CITY OF NORTHFIELD, MN
CITY COUNCIL RESOLUTION 2023-095

APPROVING A PRELIMINARY PLAT FOR CEDAR MEADOWS

CEDAR MEADOWS DEVELOPMENT

C3

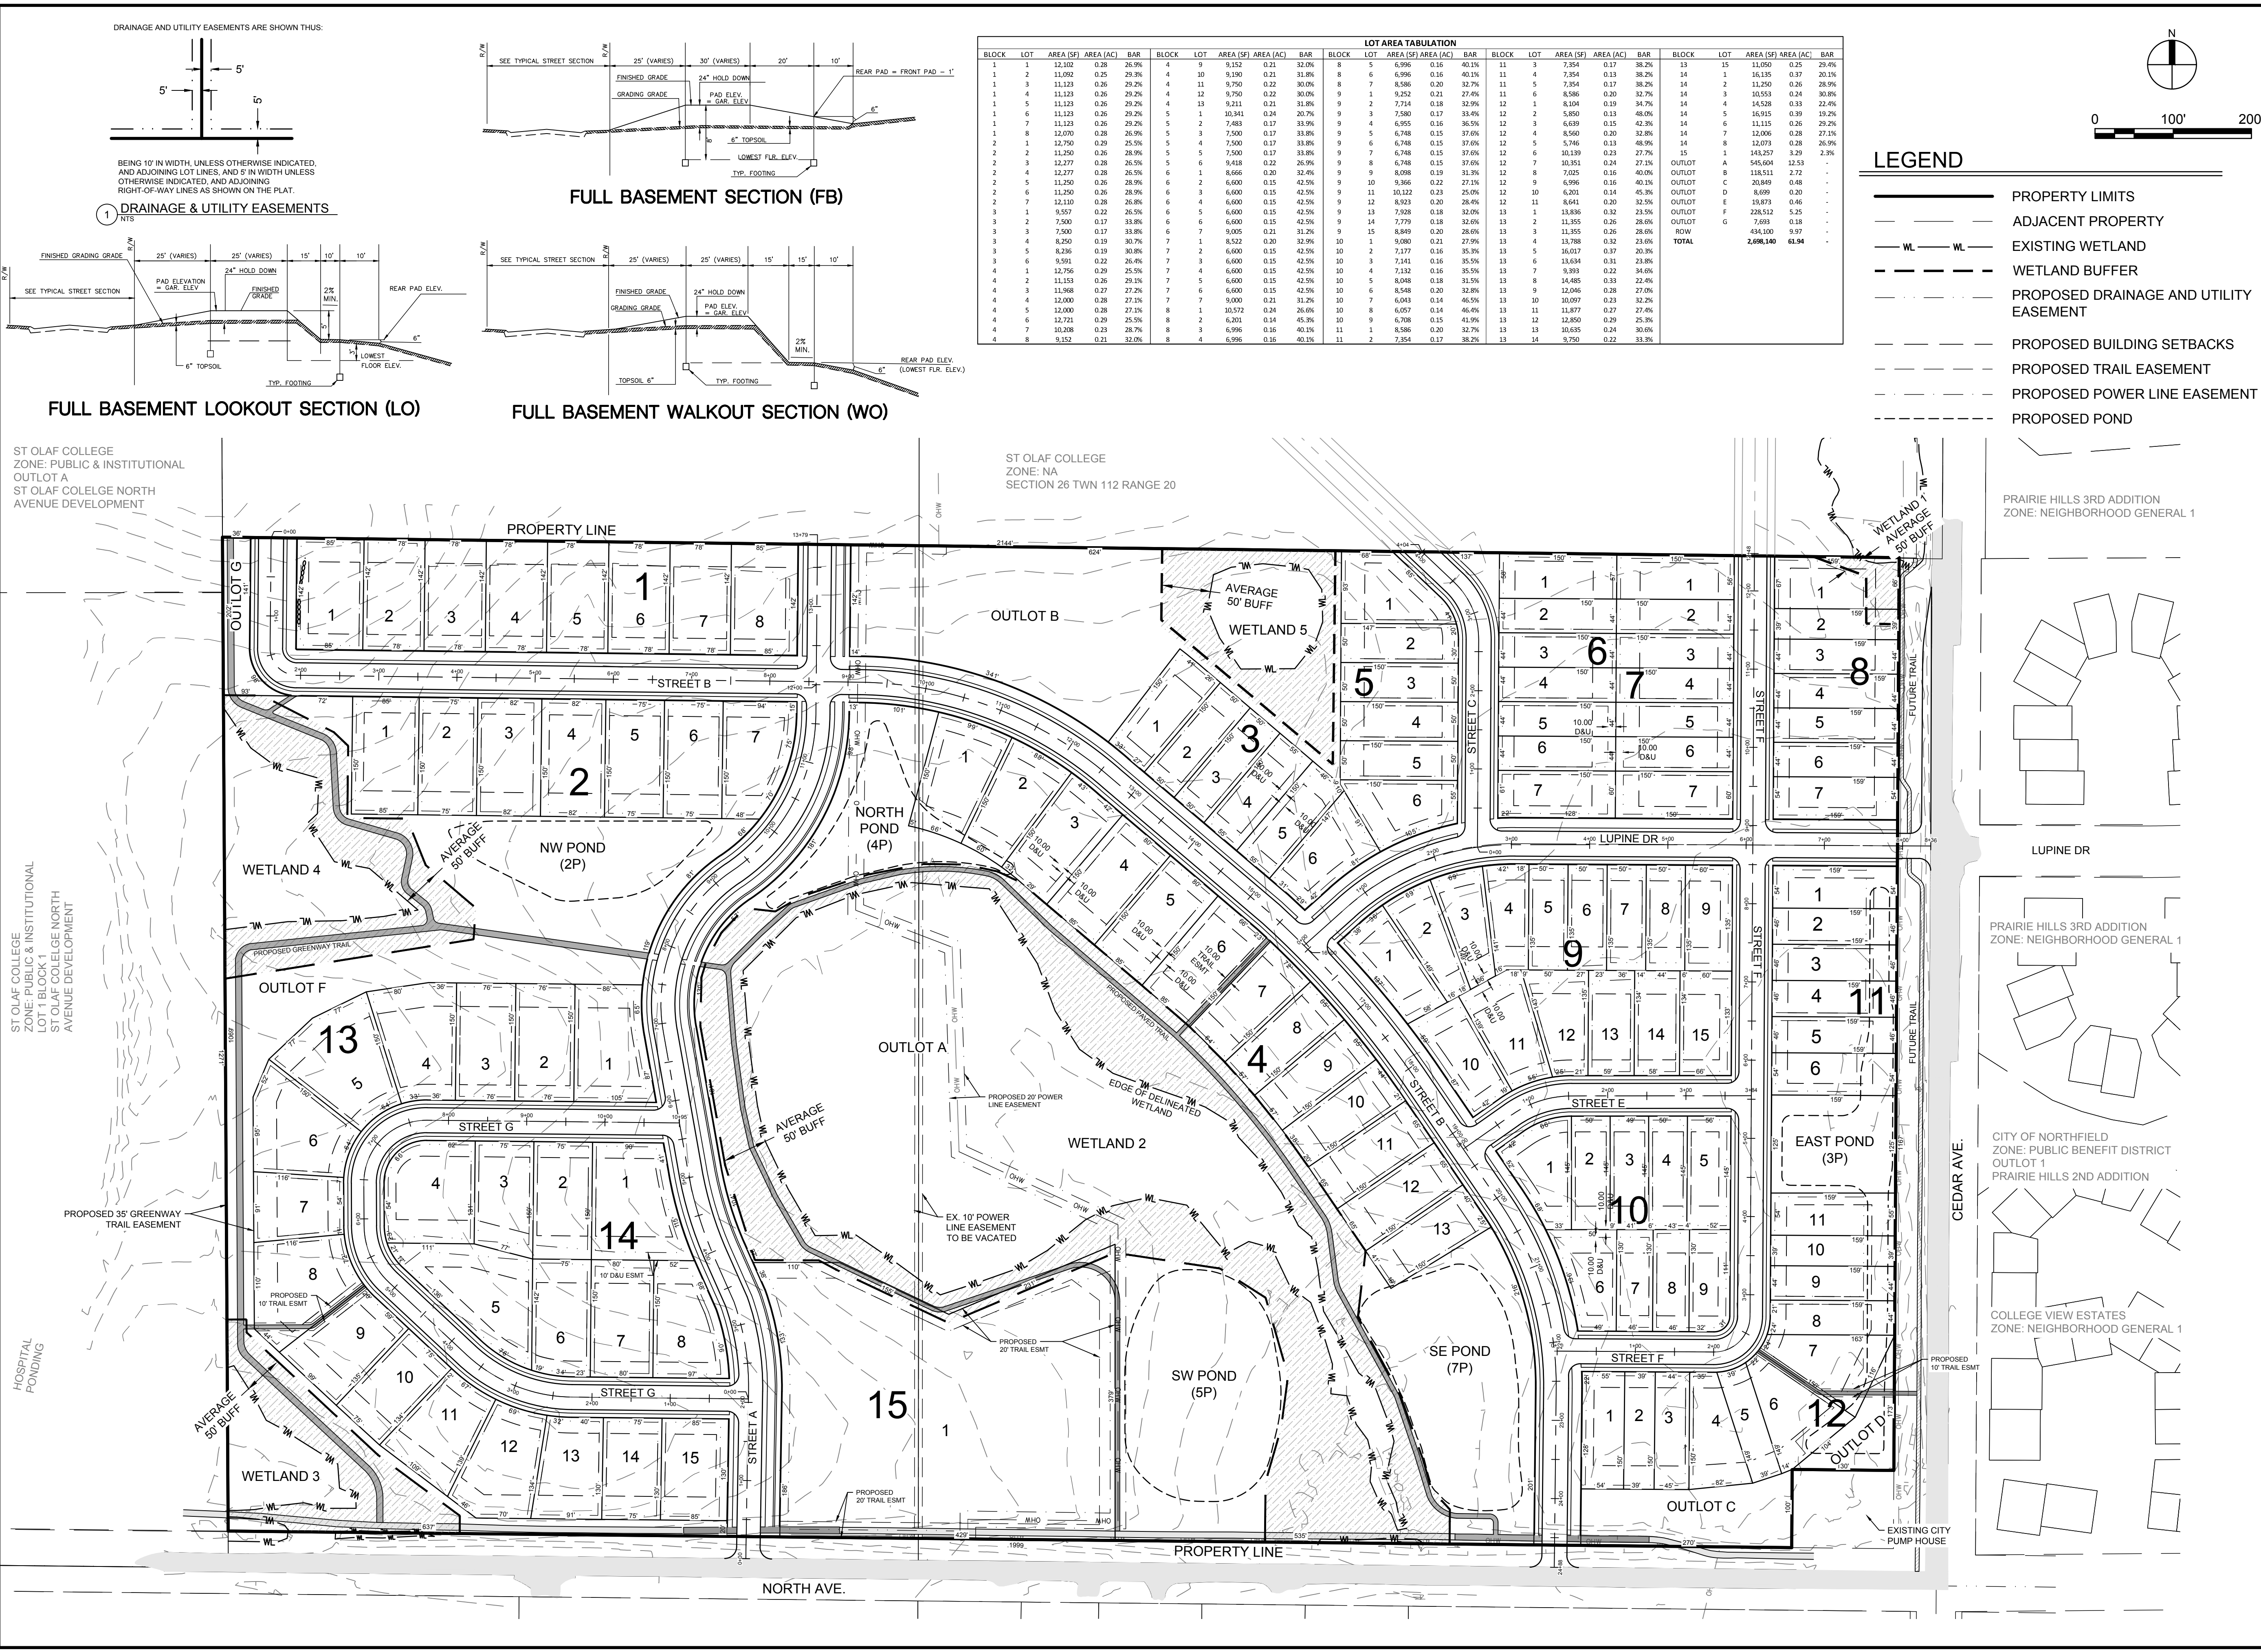
6. Street design specifications shall be consistent with the “Street” classification in the Street Type Table in Northfield’s Pedestrian, Bike and Trail Plan (2019) and be included in the Development Agreement, as follows:

- a. Street A shall include a 10-foot boulevard, no parking on both sides of the street and reduce the street width to 24 feet (10 ft. drive lanes, 2 ft. curb reaction) wide for an approximate 70-foot ROW.

- b. Construct Street B to align and connect to existing hospital road. The City will work with the land owner, hospital, St. Olaf and the developer to make this connection occur.

- c. Street B and Lupine Dr. shall be adjusted to a street width of 28 feet (7 ft. parking, 19 ft. travel way, 2 ft. curb reaction), with parking only on the north/east side, a 6-foot sidewalk on the south/west side, a 12-foot shared path on the north/east side and 7 ft boulevards for an approximate 62-foot right-of-way (ROW).

- d. Street C - G shall be adjusted to a street width of 28 feet (7 ft. parking, 19 ft. travel way, 2 ft. curb reaction), parking on one side, 6-foot sidewalks on each side, an 7-foot boulevard and sidewalk needs to be one-foot interior to the ROW line creating an approximate 56-foot ROW.

Figure 1. Bikeway recommendations within proposed development

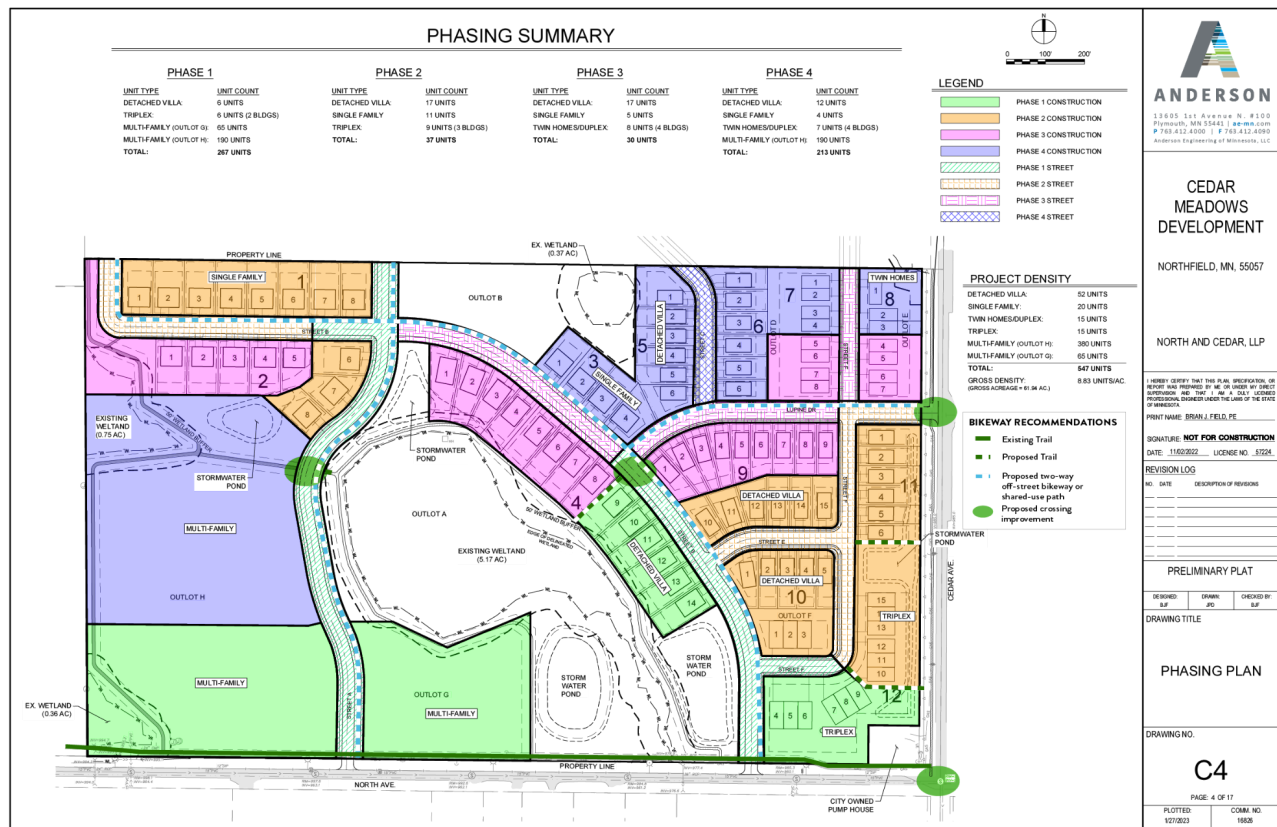
1. Include a separated bikeway on Street A and Street B as part of Phase 1 of construction. When the rest of Street B is constructed as part of Phase 3 of construction, include a separated bikeway along that part of the corridor to facilitate bikeway connections to the north and west. The cross section can be based on Figure 2 or Figure 3 (below) from the Analyzation report. Where bikeways cross driveways, maintain bikeway at sidewalk level to establish priority of trail users over vehicles. The bikeways shown in Figure 1 are located on the sides of the streets

with fewer driveways. Consider using permeable pavement on bikeway, sidewalk, and/or parking areas. In determining how to allocate right-of-way space, consider street tree needs. Four feet of boulevard space on either side of the root flare (base of the tree) is ideal for tree growth and minimizing disturbance to paved surfaces.

2. In Phase 1, include a trail connection between lots 8 and 9 of the detached villas from Street B to the trail encircling the wetland between lots 8 and 9 of the detached villas.
3. Include a separated bikeway or shared-use path connection on Lupine Drive between Cedar Avenue and Street B when Phase 2 and 3 are constructed.
4. To create a grid for biking and walking (in alignment with Northfield's Comprehensive Plan), include a shared-use path connection from Street F connecting to Cedar Avenue as part of Phase 1 and from Street E to Cedar Avenue as part of Phase 2.
5. Include intersection improvements at North Avenue and Cedar Avenue and at Lupine Avenue and Cedar Avenue. Connect with the county to coordinate on possible intersection improvements.

6. Include curb extensions with rain gardens or other green infrastructure at T-intersections and at the trail crossing across Street A.
7. Construct intersections internal to the development as raised intersections to calm traffic.

Pedestrian Improvements across Cedar Ave. at Lupine Dr. and North Ave.

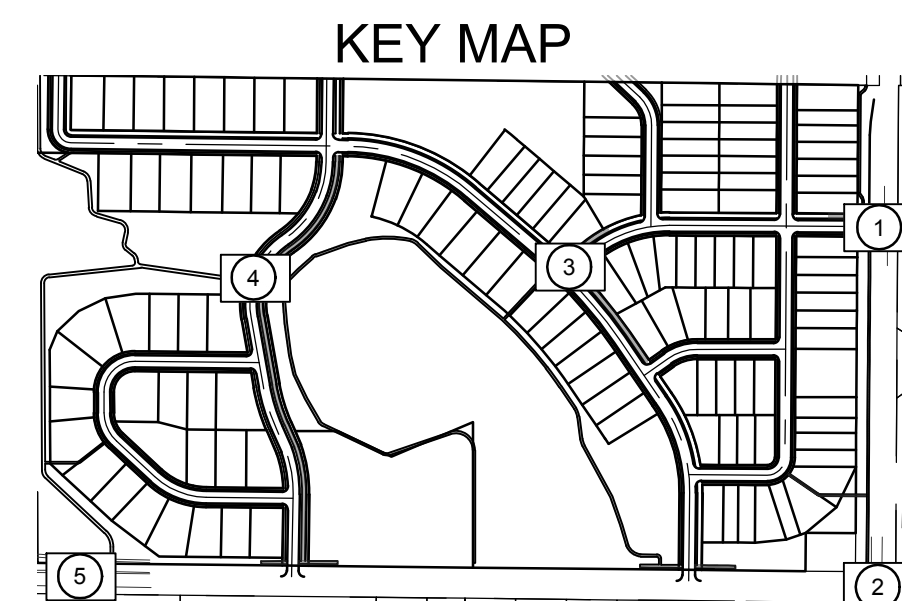
8. Implement the pedestrian improvements across Cedar Ave. at Lupine Dr. and North Ave. as submitted by the Applicant and shown in Drawing C3 (See Exhibit F), or designs substantially similar to improve safety and enhance connectivity, pending approval from Dakota County, which shall be included in the Development Agreement.
